SURRY POWER STATION, UNIT NO. 1

Amendment No. 87
License No. DPR-32

AMENDMENT NO. 87 TO FACILITY OPERATING LICENSE NO. DPR-32

SAFETY EVALUATION BY THE OFFICE OF NUCLEAR REACTOR REGULATION
RELATED TO AMENDMENT NO. 87 TO FACILITY OPERATING LICENSE NO. DPR-32

FIGURE 3.12-1A CONTROL BANK INSERTION LIMITS FOR 3-LOOP
NORMAL OPERATION-UNIT 1

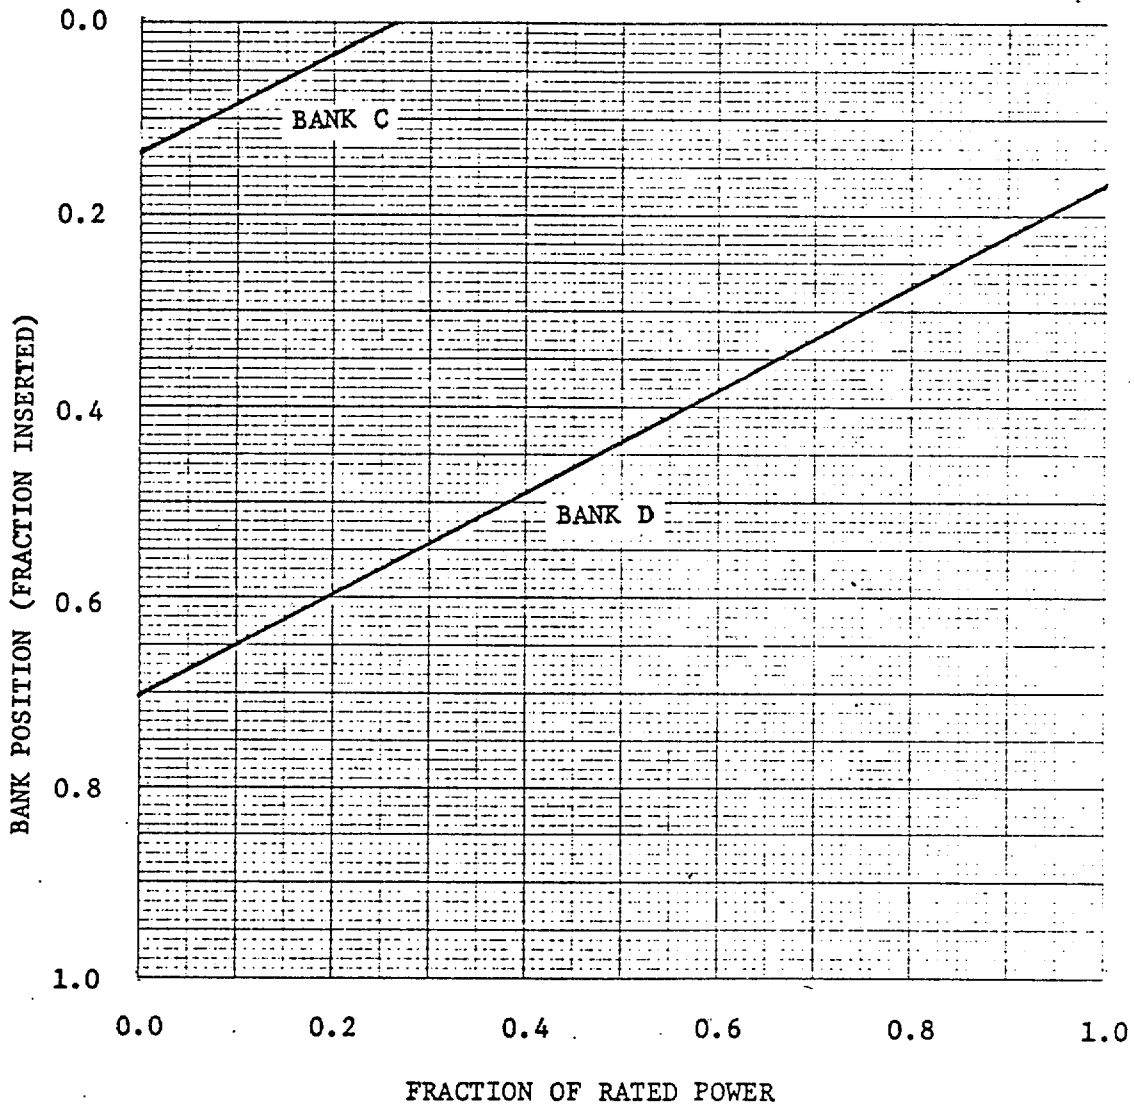
The amendment revises the Technical Specifications to raise the control rod bank insertion limits.

By letter dated April 14, 1983, Virginia Electric and Power Company (the licensee) requested an amendment to Surry Power Station, Unit No. 1. This amendment would revise the Technical Specifications to change the control rod insertion limits.

The revised core loading configuration required another reload Safety Evaluation. The reload Safety Evaluation provided is based on analysis performed by Westinghouse in accordance with the methodology documented in Westinghouse Topical Report WCAP-9272. The results indicated that no key analysis parameters would become more limiting during Cycle 7 operation than the values assumed in the currently applicable safety analysis. The basis of this evaluation include the assumption of a revision to the presently approved control rod insertion limits. The revised insertion limits are required to meet the current radial power peaking factor design limits for Cycle 7 operation.

We have reviewed the proposed Technical Specification on control rod insertion limits and conclude that they are acceptable since the insertion limits have been obtained using methods previously approved by NRC.
